title SITE WORK

project
NEW BRANCH OFFICE FOR
MIDDLESEX BANK
NUN SQUARE, CHICHESTER, MA

C1

Comm. from George Teso, Traffic Director,
re: petition of Middlesex Bank for driveways
at 1394 Cambridge Street.

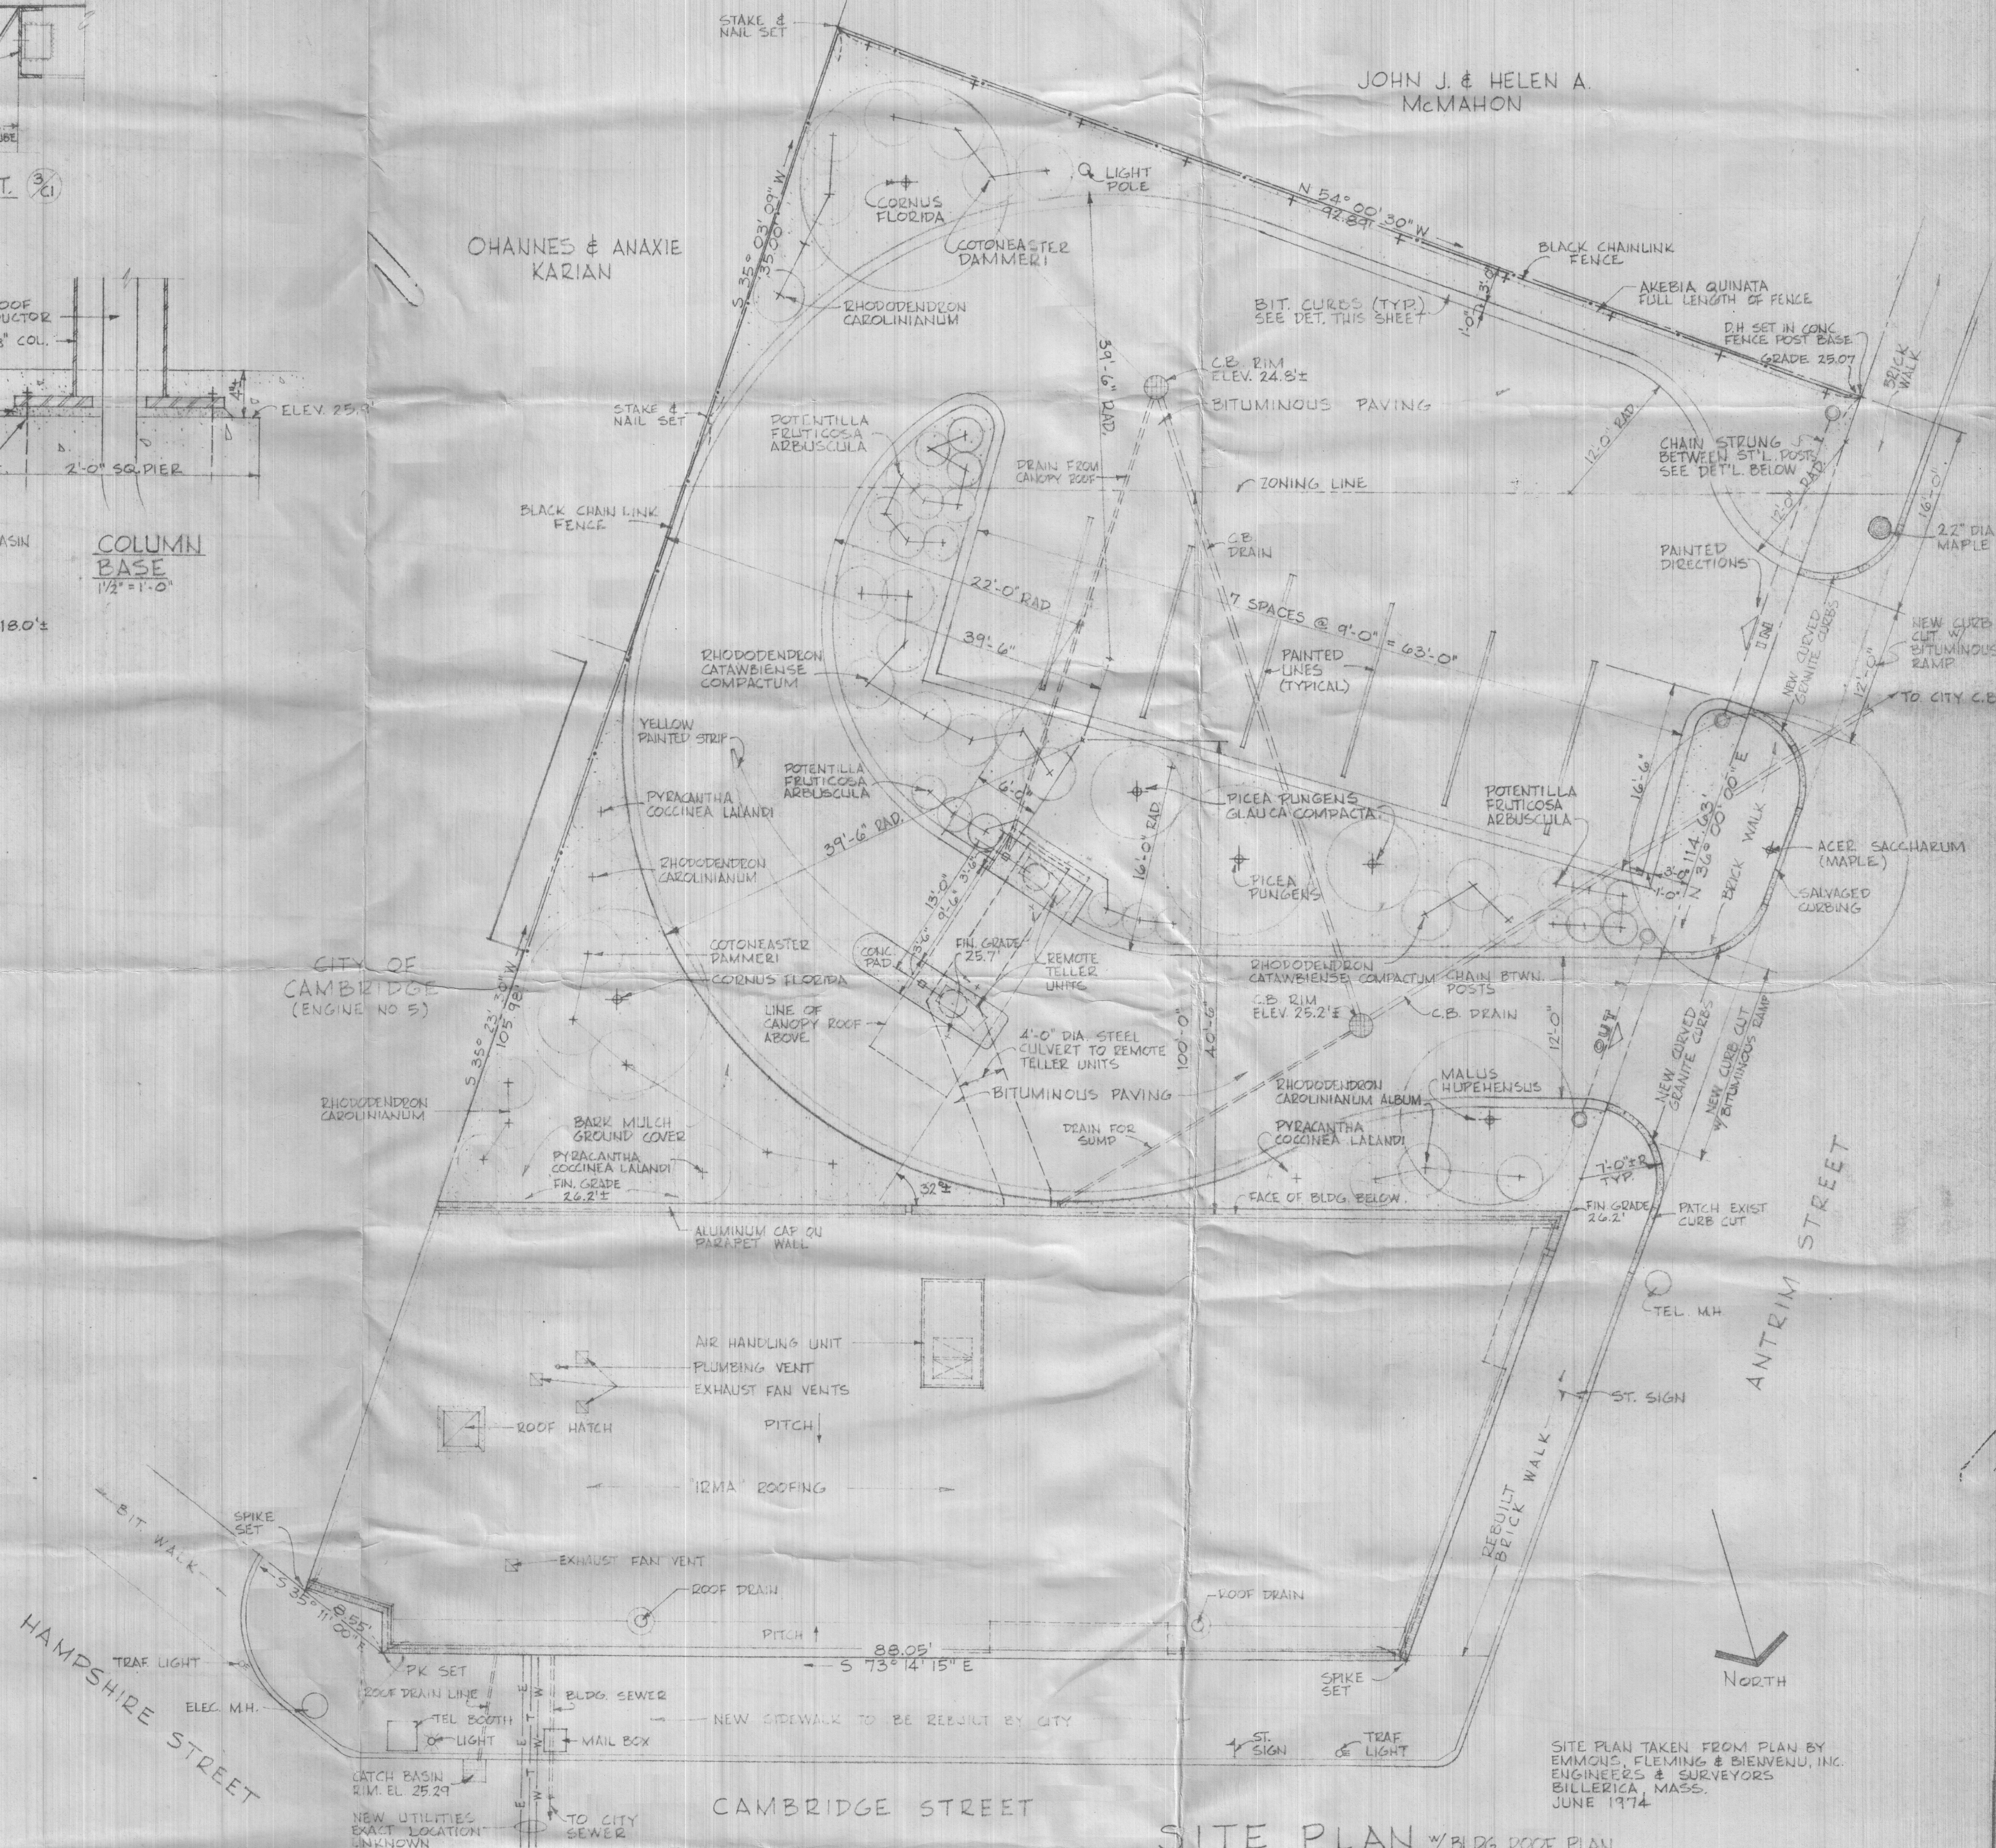
A brief summary of our decision is that with the bank open between the hours of 9:00 AM to 3:00 PM and we insisted on the 9:00 AM time so that it did not conflict with children going to school and an estimated total of 150 vehicles using the facility per day as determined by the number of persons now using their bank in Inman Square, it was decided that there would be an increase of approximately 12 vehicles an hour on Antrim Street.

The Traffic Department then discussed this with the Mid-Cambridge Neighborhood Group and both parties agreed that the effect this driveway would have on Antrim Street would be minimal. It was then that the Traffic and Parking Department approved the permit for this driveway.

I have reviewed the proposed driveways to be constructed on Antrim Street for use by the new Middlesex Bank. I have also discussed these driveways with the Mid-Cambridge Neighborhood Group and recommend that they be approved.
